## LINCOLN CITY/LANCASTER COUNTY PLANNING STAFF REPORT

**P.A.S.#:** Special Permit #441D  
NE YMCA

**Date:** July 25, 2001

**PROPOSAL:** The Harland Taylor Homeowners Association and the Y.M.C.A. request an amendment the special permit for recreational facility to show a parking lot north of the Northeast Y.M.C.A. building.

NE YMCA Recreation Facility  
 Special Permit #441c

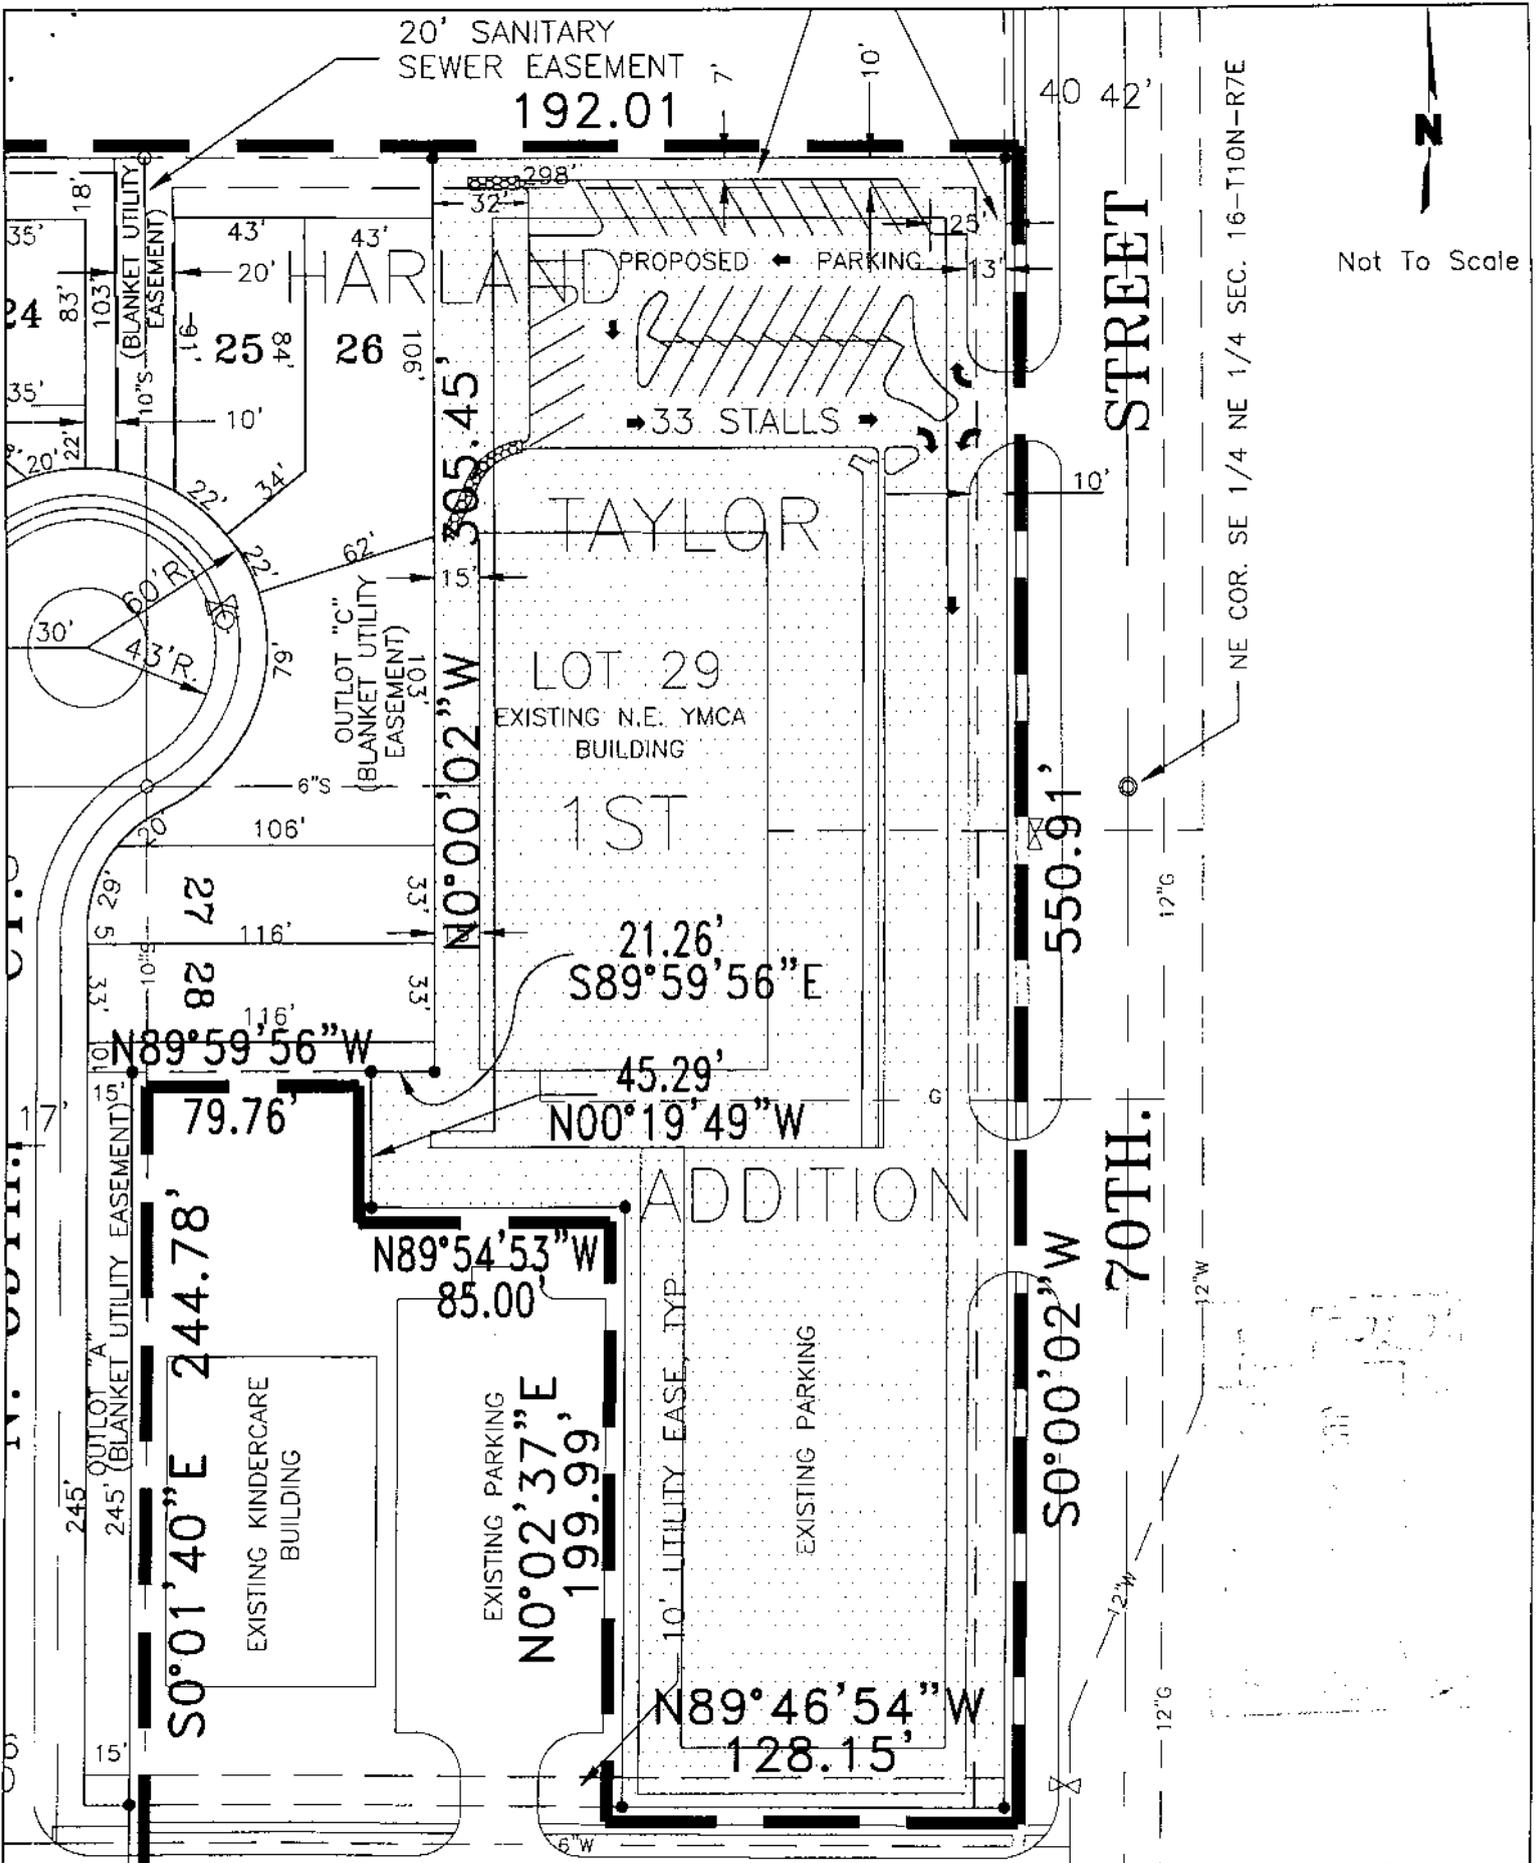
1. Storm water is shown to be concentrated and discharged from the parking lot expansion and surface drained across the Harland Taylor housing development. Rather than surface drain the water and cause potential problems across the residential lots. I recommend that the drainage be picked up in a single inlet and piped to the storm sewer or open drainage ditch in Harland Taylor Addition. The grading plan submitted does not show any existing defined drainage channel were the parking lot is presently proposed to discharge.
2. The new parking lot as shown is satisfactory subject to the drainage revisions.

1. A Landscape Plan needs to be provided for N. 70<sup>th</sup> Street & Huntington Avenue.
2. Patmore Ash is the street tree and needs to be spaced at 50 – 55' apart and 5' from back of curb to meet traffic standards along N. 70<sup>th</sup> Street.

It should be noted, any relocation of existing facilities will be at the owner/developer's expense.

1. Before receiving building permits:
  - 1.1 Revise the site plan to show:
    - 1.1.1 The correct type of special permit.
    - 1.1.2 Remove the approval block.

- 1.1.3 A note indicating that any relocation of existing facilities shall be at the owner/developer's expense.
    - 1.1.4 Provide a landscape plan for N. 70<sup>th</sup> Street and Huntington avenue.

- 1.1.5 Revise the grading plan to the satisfaction of the Public Works and Utilities Department.
    - 1.1.6 Revise the drainage to the satisfaction of the Public Works & Utilities Department.

- 1.2 Revise the landscape plan to show:
    - 1.2.1 Screening that meet the City of Lincoln Design Standards for Screening and Landscaping.
    - 1.2.2 Landscaping that meets the City of Lincoln Design Standards for parking lots.

- 1.2.3 Identification of plant materials on the plan.
  - 1.3 Amend the Special Permit to show the location of the parking lot.
  - 1.4 The permittee shall have submitted a revised and reproducible plan including 5 copies of the approved plans.
